ADDENDUM

ADDENDUM NO.:	06

PROJECT NAME: Sauganash Elementary School Annex II and Renovations

DATE OF ISSUE: November 8, 2021

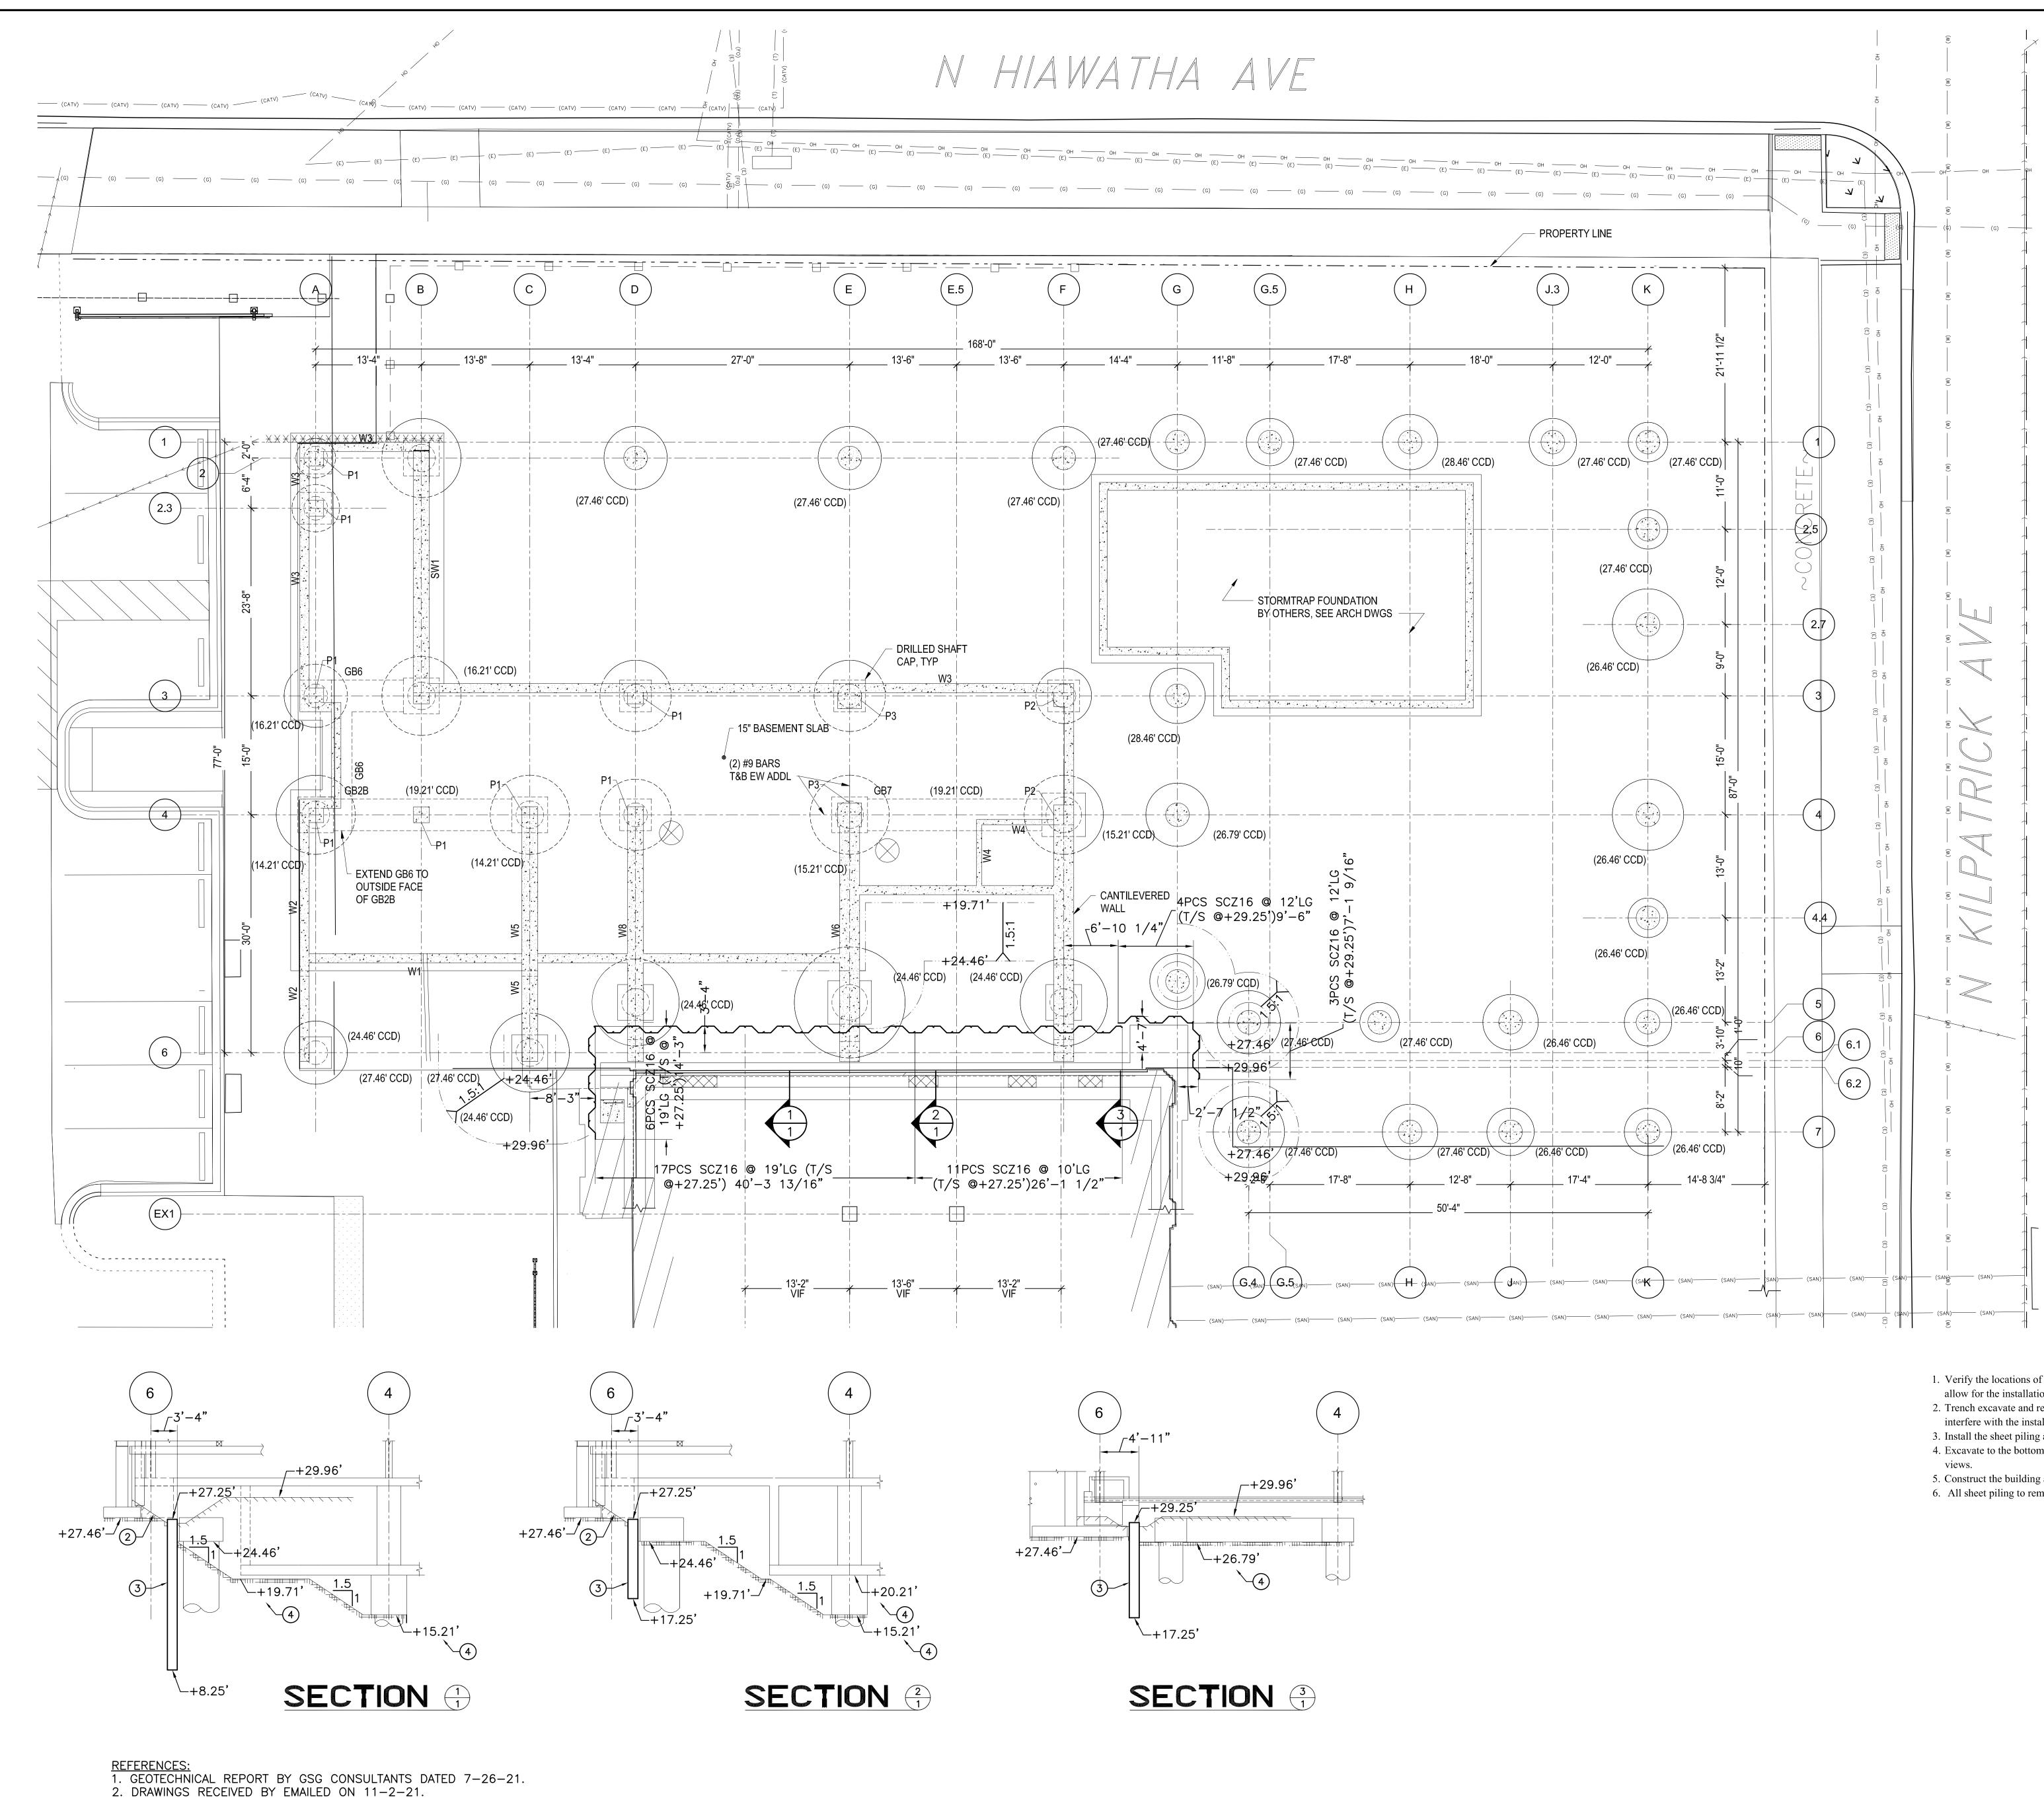
a.
 Revised drawing index.
 - Change 2 ADDED Drawing No. ERS0, Notes.
 - Change 3 REVISED Drawing No. ERS1, Earth Retention System.
 - a. ERS location slighting revised in plan.
- ITEM NO. 6: REQUESTS FOR INFORMATION
